## **LLANFAIR SOUTH YESTER OAK SUBDIVISION**

The applicant is requesting Subdivision approval to create one (1) legal lot of record from one (1) existing legal lot of record (altering recorded setbacks).

APPLICATION NUMBER 4 DATE June 2, 2022

## SITE PLAN

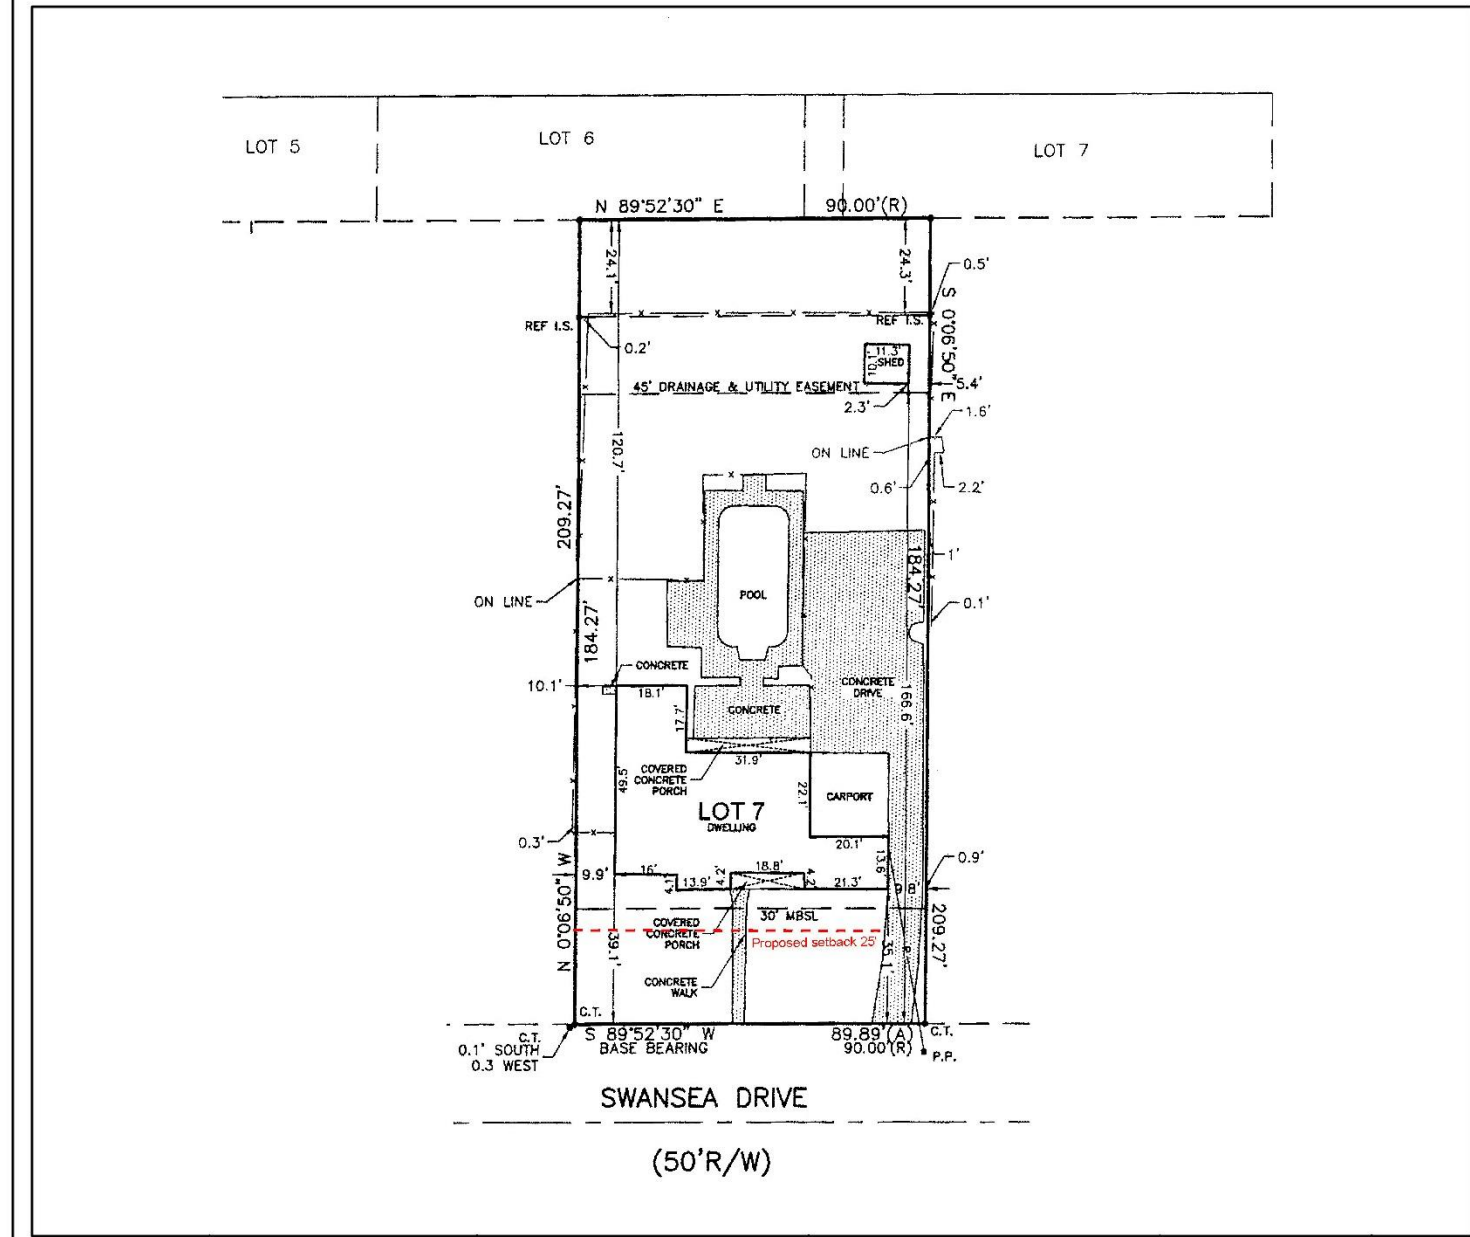
It should be noted that only a copy of the recorded plat was provided with the proposed setback depicted, no preliminary plat was submitted for the Subdivision review. Therefore, a Final Plat plat should be submitted indicating the proposed amended setbacks for the subject site.

The site has frontage on Swansea Drive, a minor street with curb-and-gutter, which has existing compliant 50-foot right-of-way; therefore, no dedication would be required. As on the recorded plat, the right-of-way width of Swansea Drive should be retained on the Final Plat, if approved.

The recorded plat submitted indicates a proposed 25-foot minimum building setback line along Swansea Drive, and this should be retained on the Final Plat, if approved. The proposed lot is approximately 8,700± square feet which exceeds the minimum size requirements of the Subdivision Regulations. However, the recorded plat does not illustrate the lot size. If approved, the lot size in both square feet and acres should be provided on the Final Plat, or a table should be furnished on the Final Plat providing the same information, if approved.

As illustrated the submitted plat meets the minimum requirements of the Subdivision Regulations and is recommended for Tentative Approval subject to the following conditions:

- 1) provision of a Final Plat as required by Section IV.C.2. of the Subdivision Regulations;
- 2) retention of the right-of-way width of Swansea Drive on the Final Plat;

- 3) retention of the 25-foot minimum building setback line along Swansea Drive on the Final Plat;
- 4) provision of the lot size label in both square feet and acres on the Final Plat, or the furnishing of a table on the Final Plat providing the same information;
